## ARBORIST CORRECTIONS

**Project Name:** Mercer Island Treehouse

**Site Address:** 5637 East Mercer Way, Mercer Island, WA 98040  
King County Parcel # 1924059312

**Date:** August 12, 2022

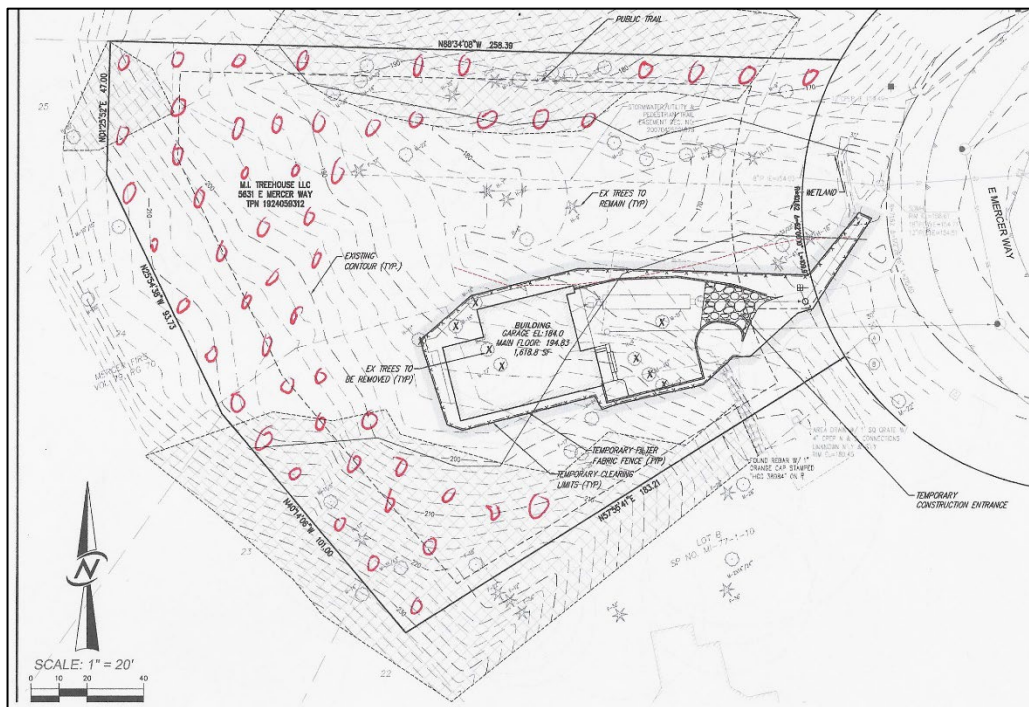
TREE-REVIEW#1  
 4. (For Architect/Arborist) It appears all the trees on site are part of an exceptional grove. Each exceptional grove tree that is allowed to be removed must be replaced by six trees. Unless they are in poor condition, then I am allowed to reduce the replacement ratio. But it would be at least one tree that is replaced. Trees will be replaced according to the following. At least half of the trees need to be Pacific Northwest native, see the following link: [https://oregonstate.edu/trees/name\\_common.html](https://oregonstate.edu/trees/name_common.html). The trees need to be at least 10' apart from each other, structures, fences and utilities. If requested and you can show no room exists on site for all the trees, the remainder can be a fee in lieu if requested. ¶

Nine trees are proposed to be removed. They will be replaced with 6 trees each for a total of 54 replacement trees. Proposed is a schedule of native and non-native species. The proposal is for 32 native trees and 22 non-native landscape trees. The Non-native species were selected based upon a combination of their survivability on this unique site, their environmental and aesthetic benefits, as well as them *not* being invasive. The selection was also based upon what species are available at local nurseries and plant wholesale companies.

TREEHOUSE PROJECT, REPLACEMENT TREE SCHEDULE			
- 9 Exceptional Grove Trees are proposed to be removed.			
- They will be replaced with 6 trees each as required for a total of 56 replacement trees.

- The lot is large, 37,554 Square Feet. This provides adequate room to accomplish the 10-spacing requirement.			
Minimum of 1/2 Replacement Trees Native Species:

**Page 44, TREE REVIEW, # 2**

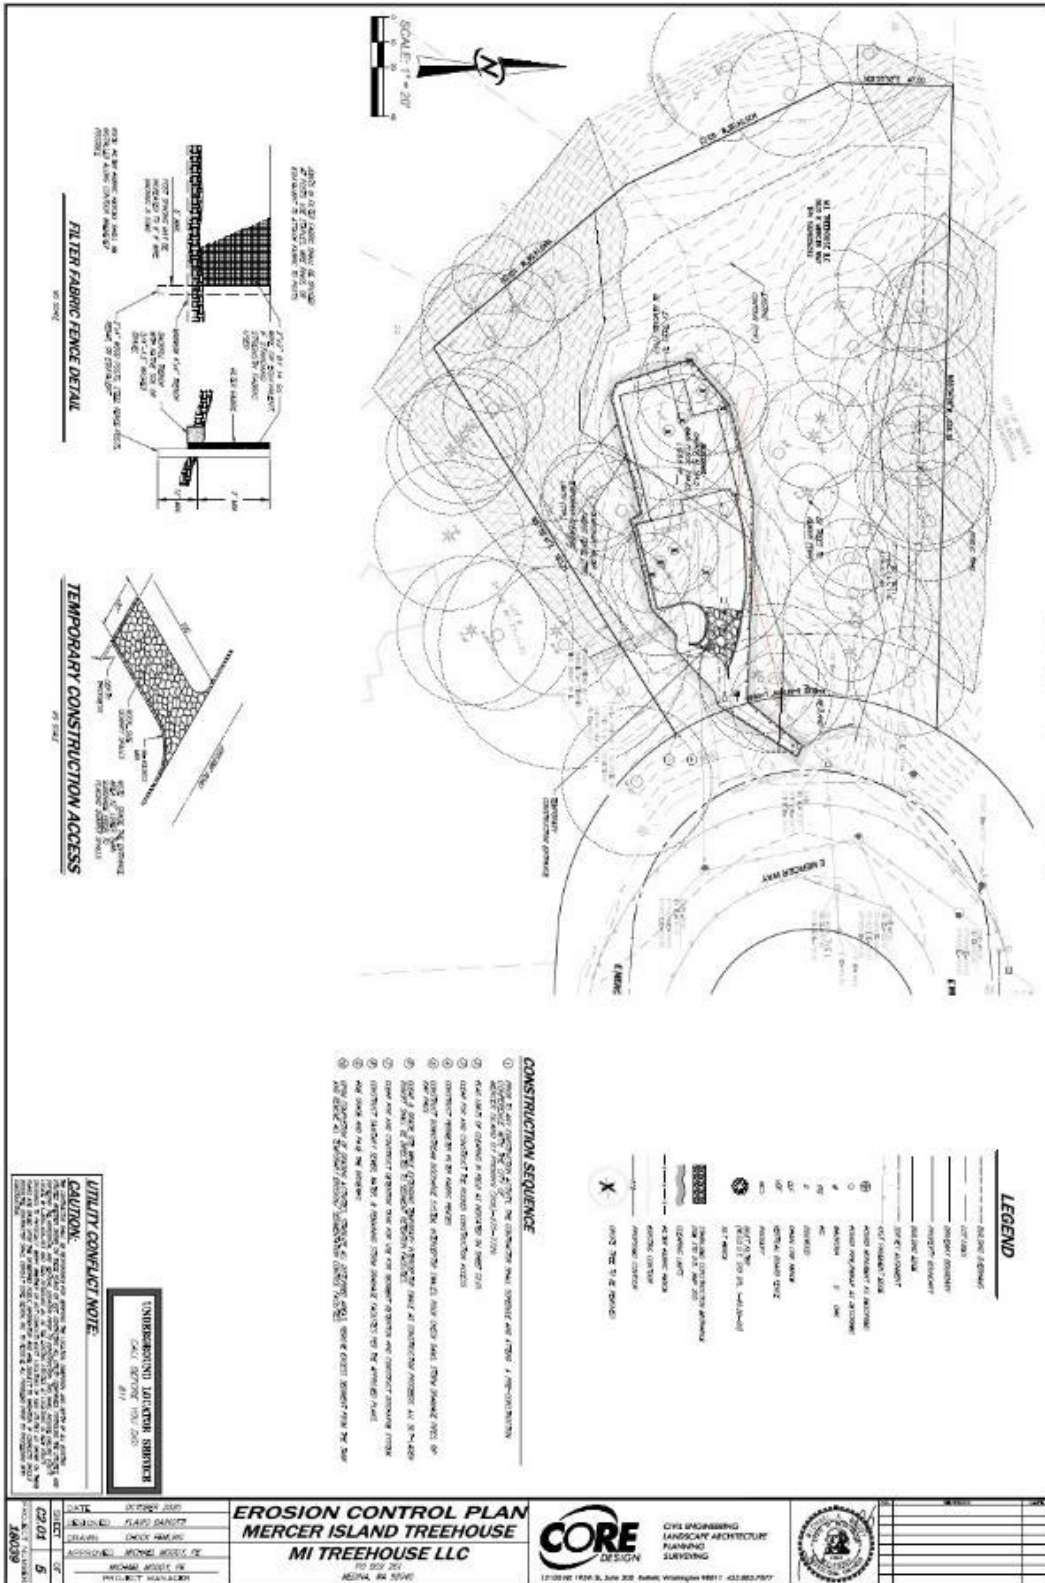
TREE-REVIEW#  
2. (For-Civil/Arborist)-Limits-of-allowable-disturbance-will-be-determined-by-the-arborist-for-all-exceptional-and-saved-trees-showing-development-within-their-driplines.. This-root-zone-analysis-should-be-determined-by-noninvasive-techniques-such-as-air-excavation.. These-limits-must-meet-the-standards-in-MICC19.10.080.. The-arborist-must-how-the-code-will-be-met.. These-limits-of-allowable-disturbance-will-be-shown-and-called-out-on-the-civil-plans. ¶

In previous reports tree protection measures were clearly outlined. These measures are called out on the Civil Plans as required.

1. Tree Protection Fence:
  - a. Tree Protection Fences will need to be placed around the tree retained on the adjacent property.
    - i. *The Filter Fabric Fencing location is the same as the tree protection fencing.*
  - b. Tree Protection Fences are to be placed according to the drawing below.
  - c. Tree Protection Fences must be inspected and approved by the City prior to the beginning of any construction work activities.
  - d. The area inside of the fence is *The Tree Protection Zone*.
  - e. The area outside of the fence is *The Development Zone*.
    - i. Nothing must be parked or stored within the Tree Protection Fences—no equipment, vehicles, soil, debris, or construction supplies of any sorts.
  - f. Tree Protection Fence Signage:
    - i. The Tree Protection Fences need to be clearly marked with the following text:
